CONSTRUCTION CONTRACT CHANGE ORDER NUMBER: 5

CCSJ:	0921-02-321
Project:	STP 2021(256) MM
Highway:	Mile 3 N
County:	Hidalgo
District:	21-Pharr
Contract Number:	C-20-294-02-23

Change Order #5
Mile 3 N Road

Project: Mile 3 N Road
Project #: STP 2021 (256) MM
Contract: C-20-294-02-23
CSJ: 0921-02-321
Limits: Tom Gill Road to FM 492 (Goodwin Road)

176a

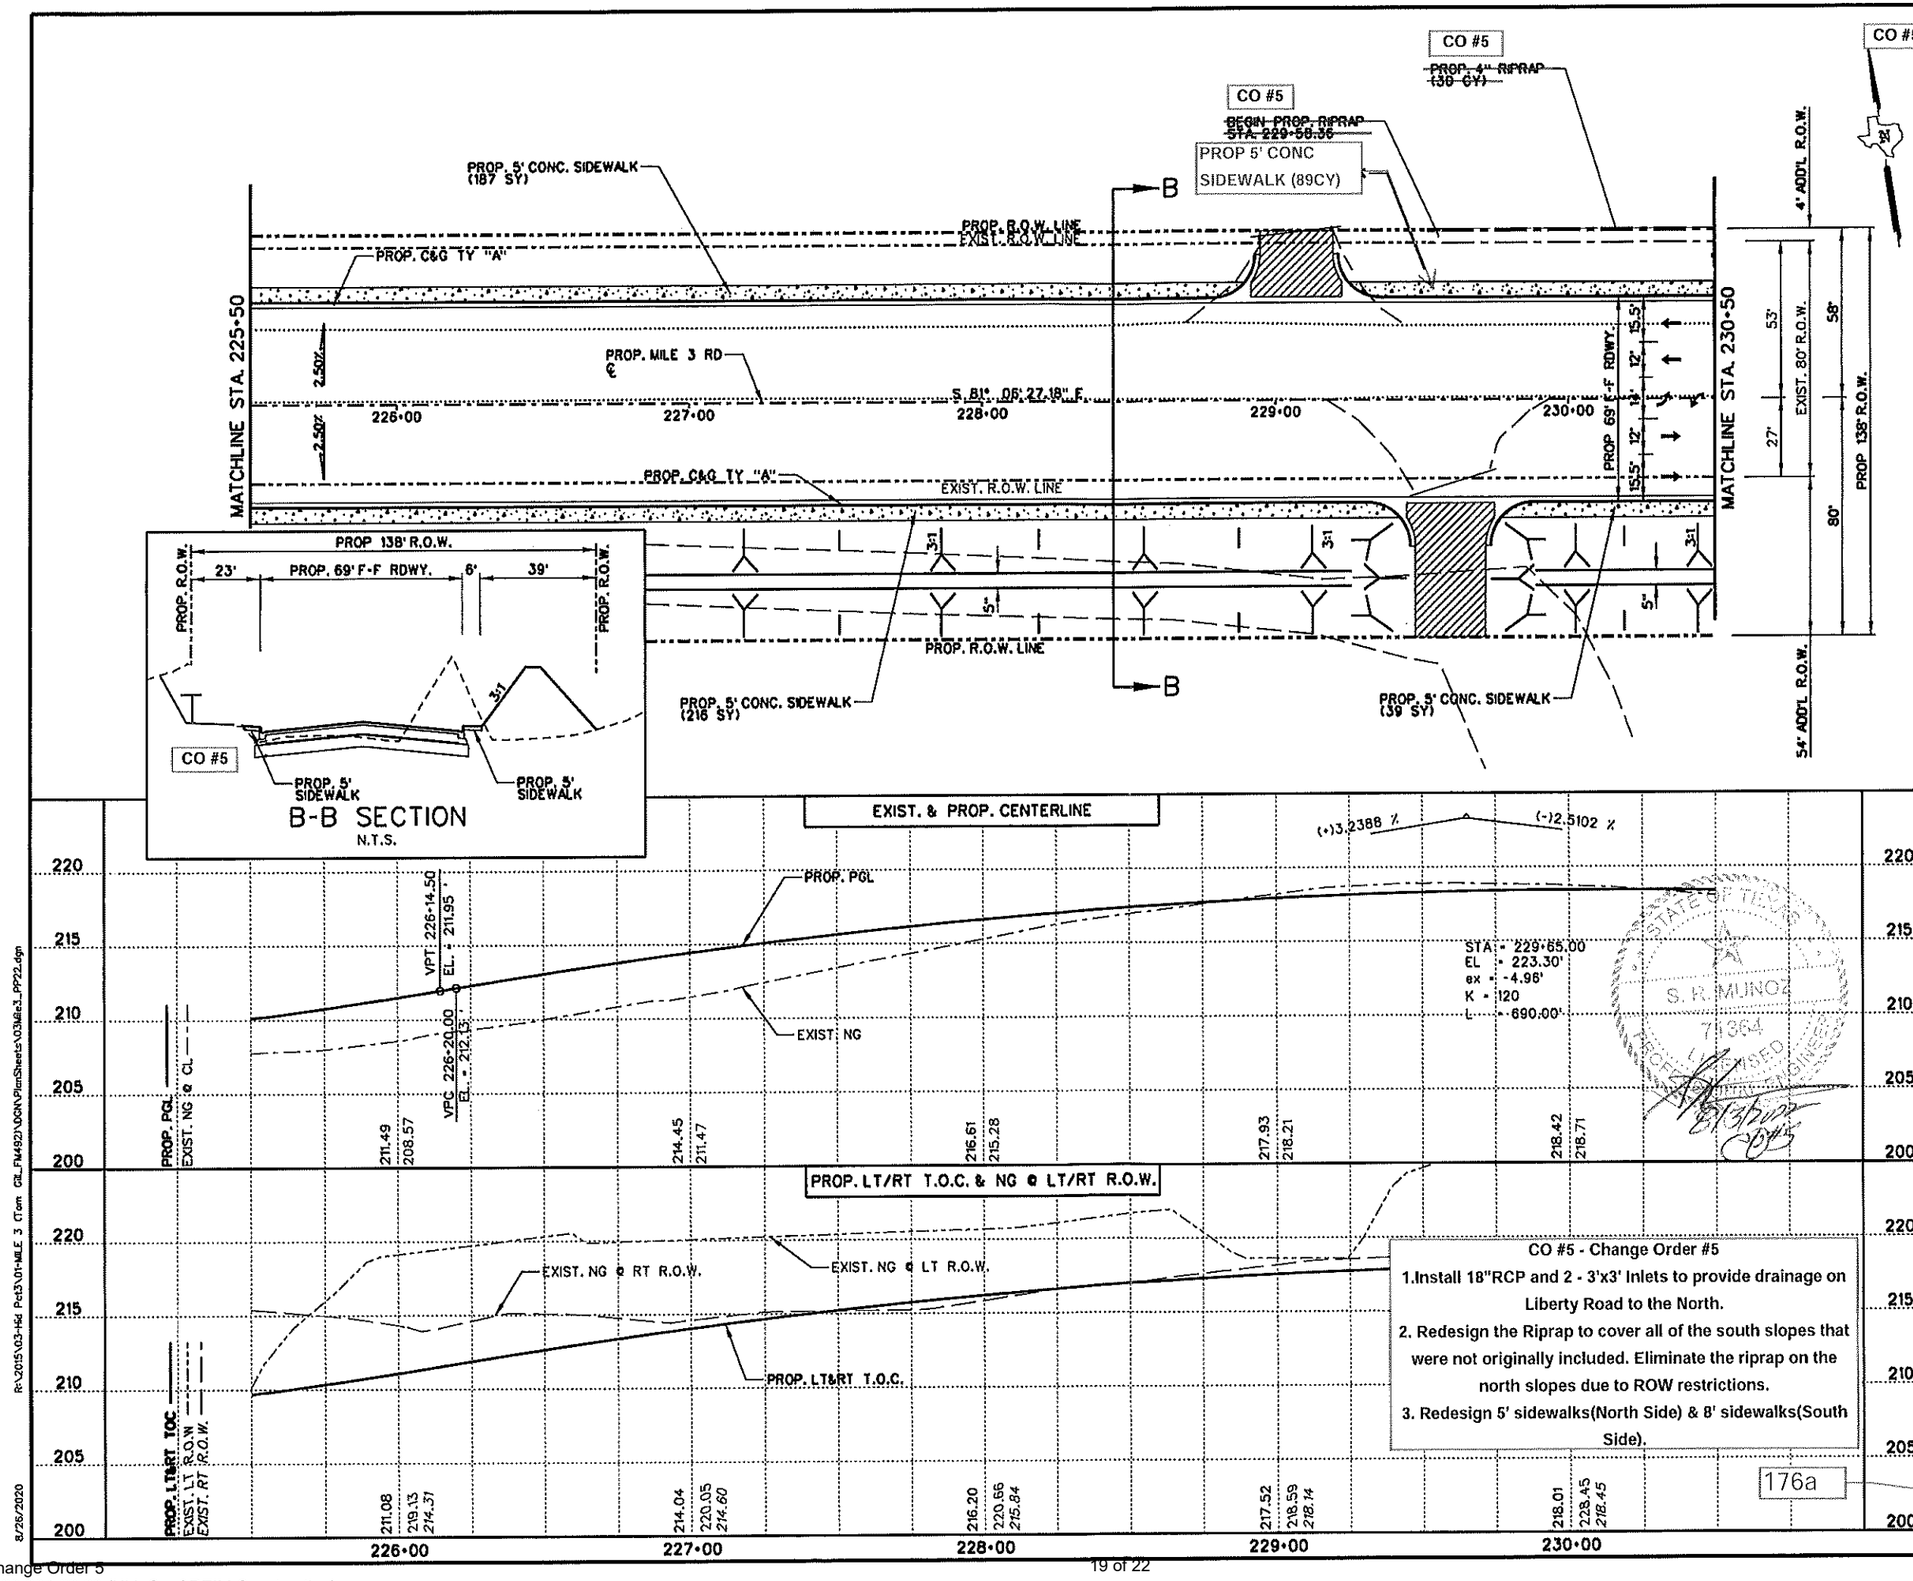
1.Install 18"RCP and 2 - 3'x3' Inlets to provide drainage on Liberty Road to the North.

2. Redesign the Riprap to cover all of the south slopes that were not originally included. Eliminate the riprap on the north slopes due to ROW restrictions.

3. Redesign 5' sidewalks(North Side) & 8' sidewalks(South Side).

ITEM	DESCRIPTION	UNIT	QUANTITY
432	CONC. RIPRAP (4")	CY	0
529	CONC. CURB & GUTTER (TY "A")	LF	1000
531	CONC. SIDEWALK (4")	SY	531

178a

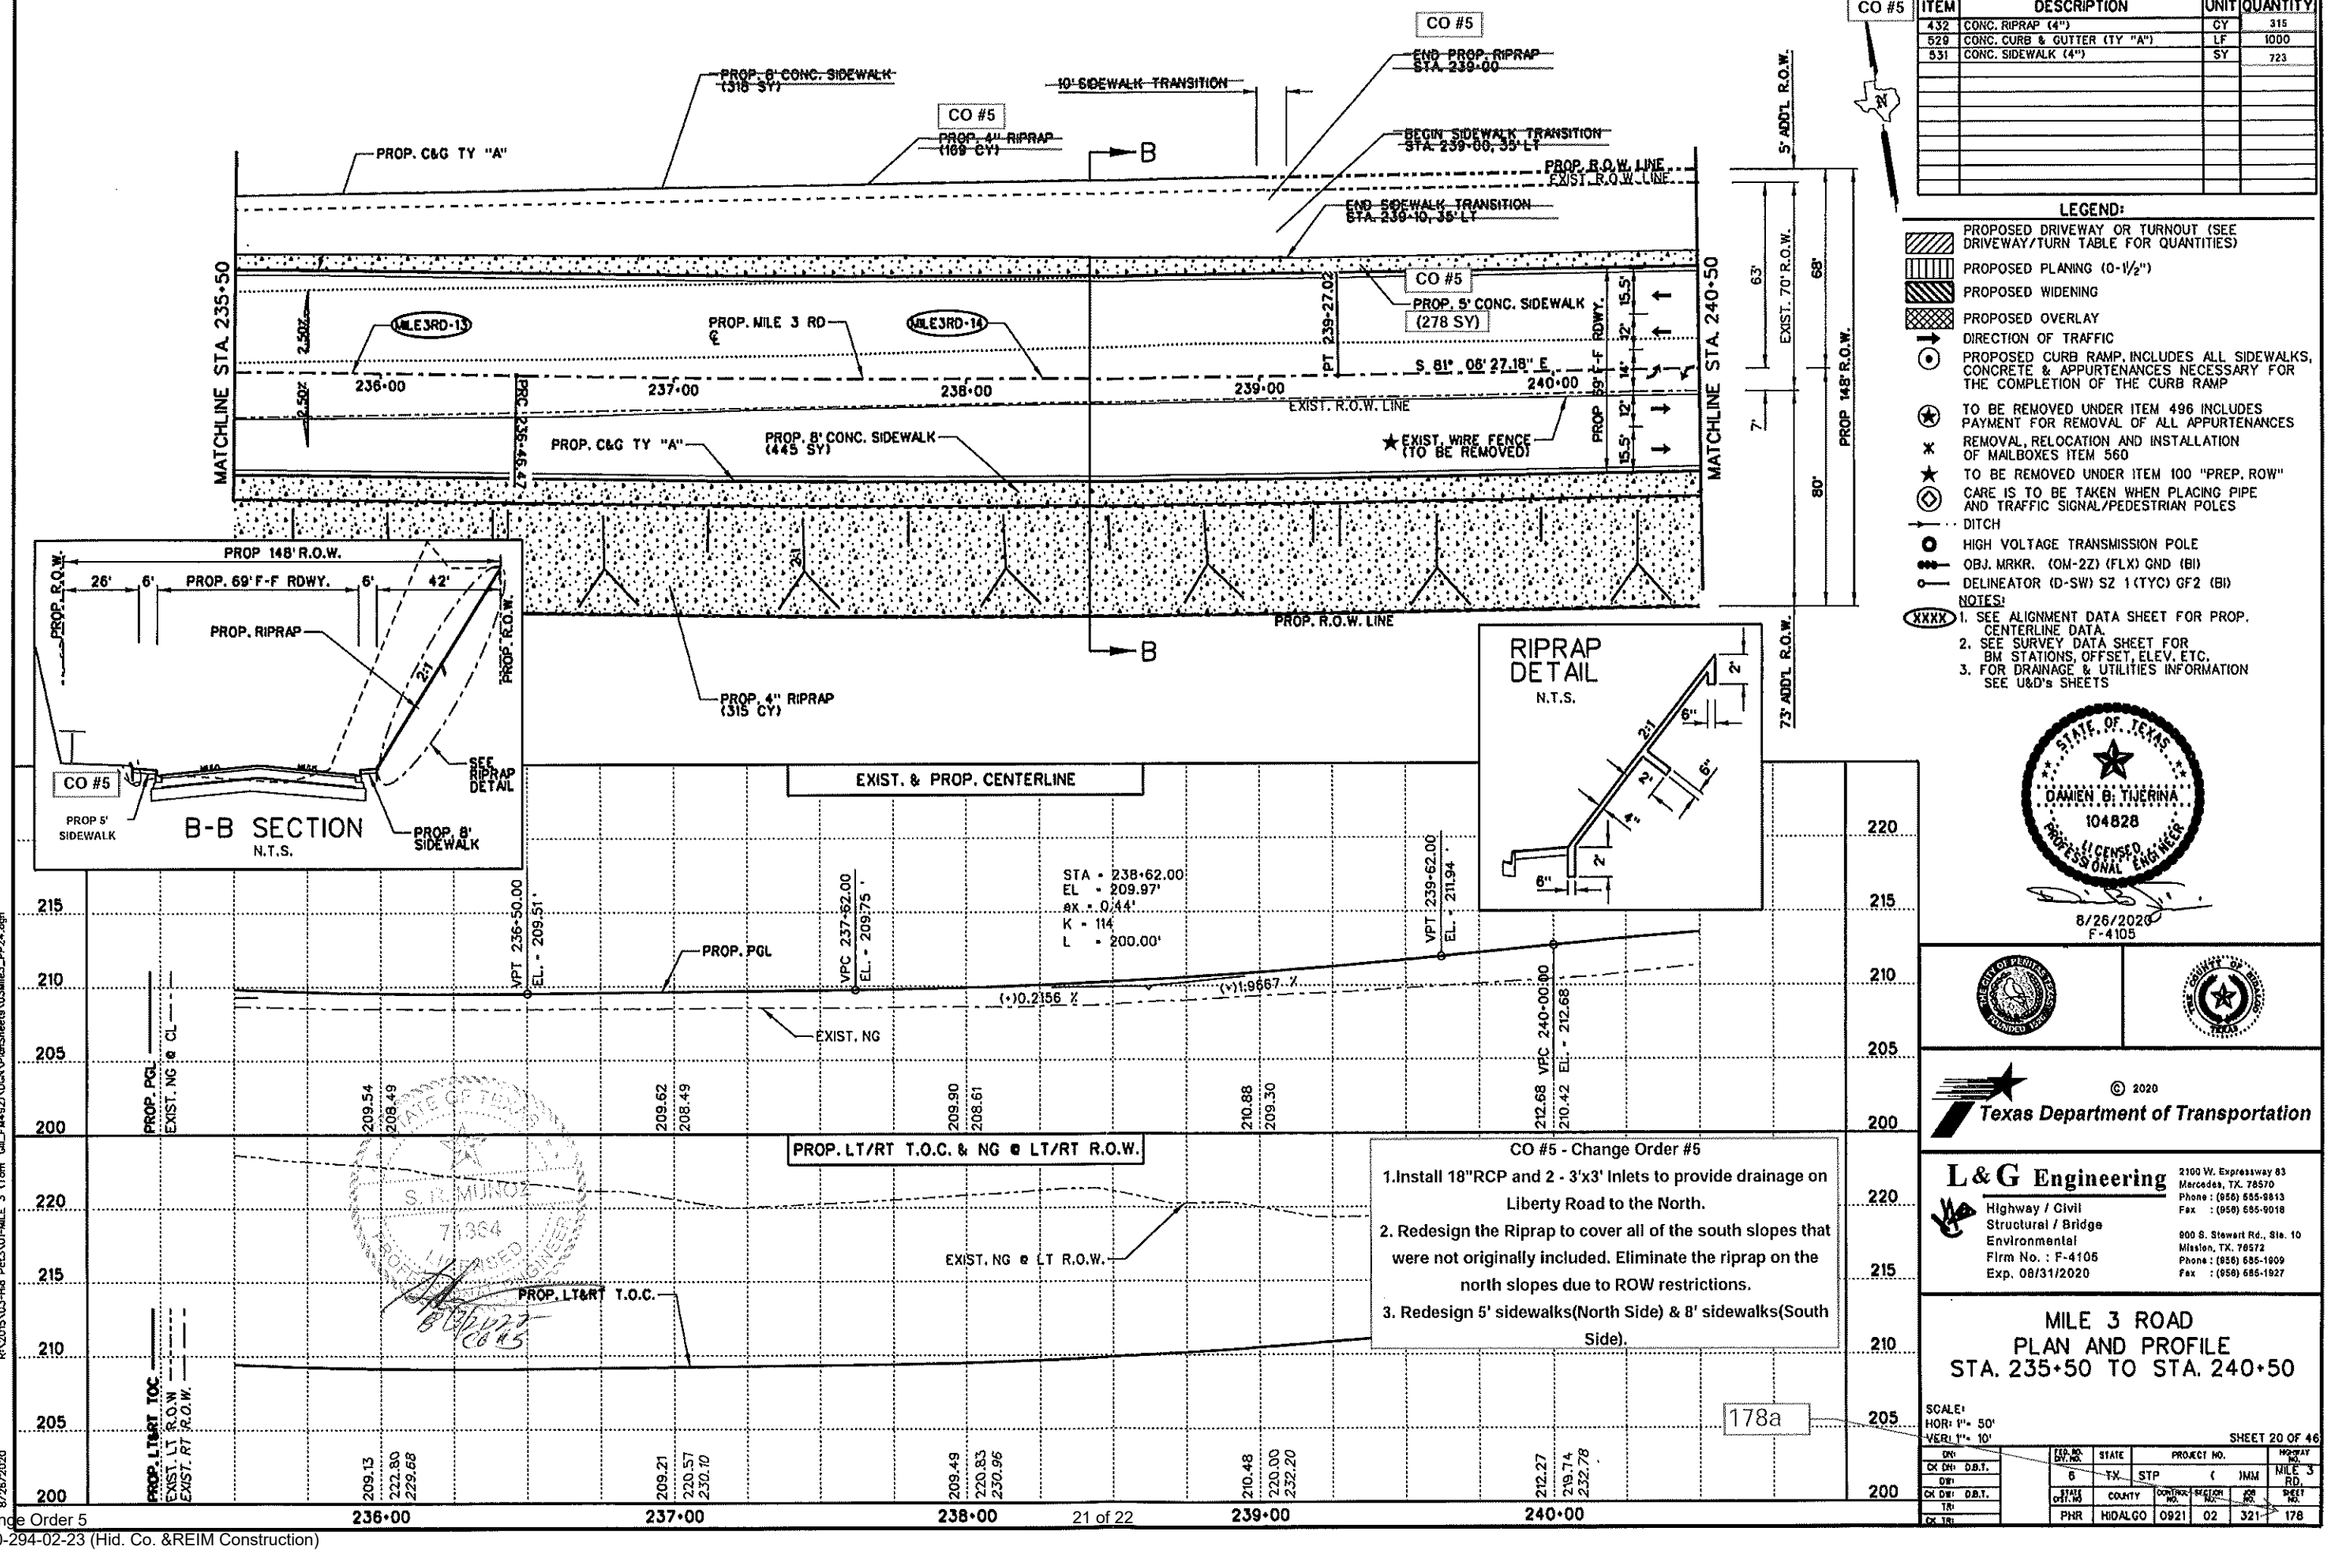
1. Install 18"RCP and 2 - 3'x3' Inlets to provide drainage on Liberty Road to the North.
2. Redesign the Riprap to cover all of the south slopes that were not originally included. Eliminate the riprap on the north slopes due to ROW restrictions.
3. Redesign 5' sidewalks(North Side) & 8' sidewalks(South Side).

ITEM	DESCRIPTION	UNIT	QUANTITY
432	CONC. RIPRAP (4")	CY	315
529	CONC. CURB & GUTTER (TY "A")	LF	1000
531	CONC. SIDEWALK (4")	SY	723

FED.RD. DIV.NO.	STATE	PROJECT NO.			HIGHWAY NO.
6	TX.	STP	(	)MM	MILE 3 RD.
STATE DIST. NO.	COUNTY	CONTROL NO.	SECTION NO.	JOB NO.	SHEET NO.
PHR	HIDALGO	0921	02	321	180

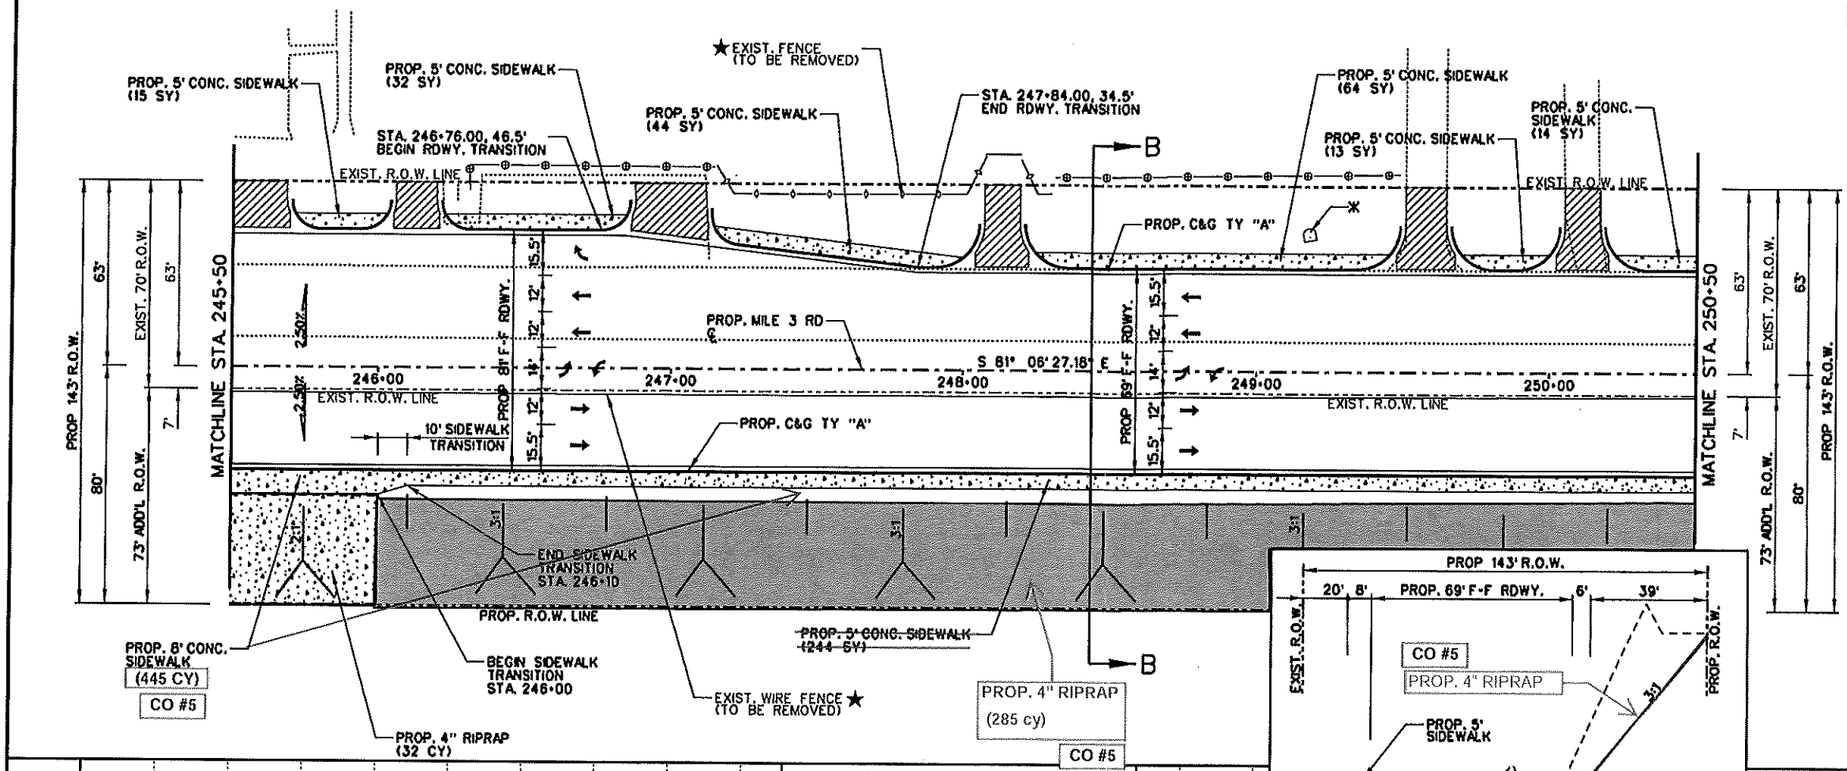
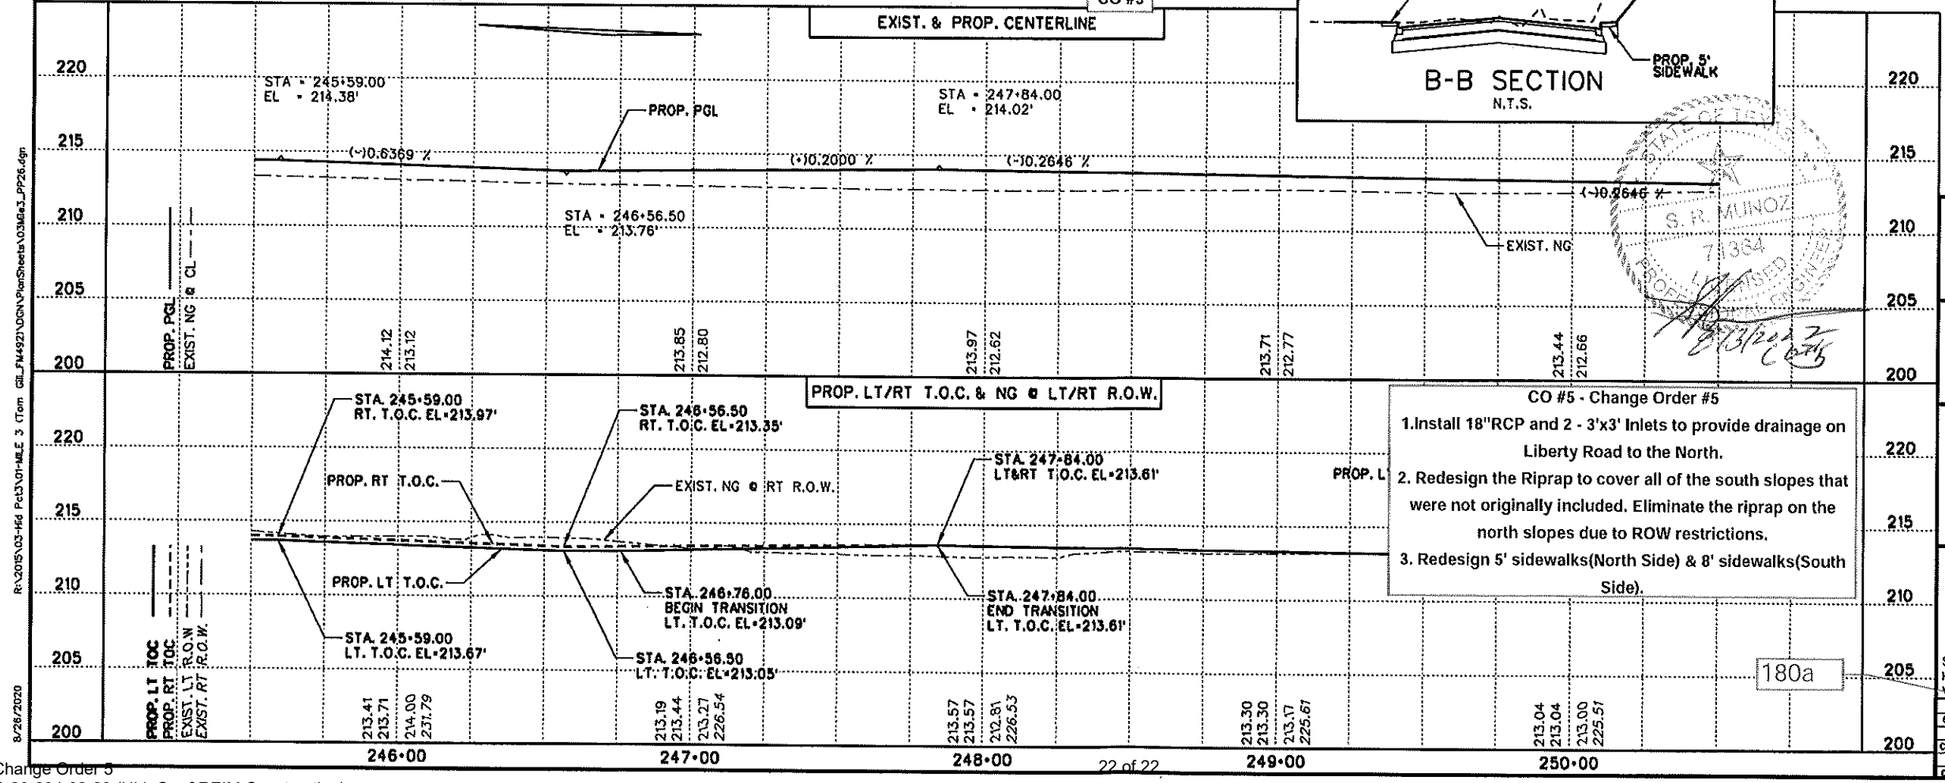
1. Install 18"RCP and 2 - 3'x3' Inlets to provide drainage on Liberty Road to the North.
2. Redesign the Riprap to cover all of the south slopes that were not originally included. Eliminate the riprap on the north slopes due to ROW restrictions.
3. Redesign 5' sidewalks(North Side) & 8' sidewalks(South Side).

CO #5	ITEM	DESCRIPTION	UNIT	QUANTITY
	432	CONC. RIPRAP (4")	CY	317
	529	CONC. CURB & GUTTER (TY "A")	LF	1001
	531	CONC. SIDEWALK (4")	SY	627
	560	MAILBOX INSTALLATION (SINGLE)	EA	1
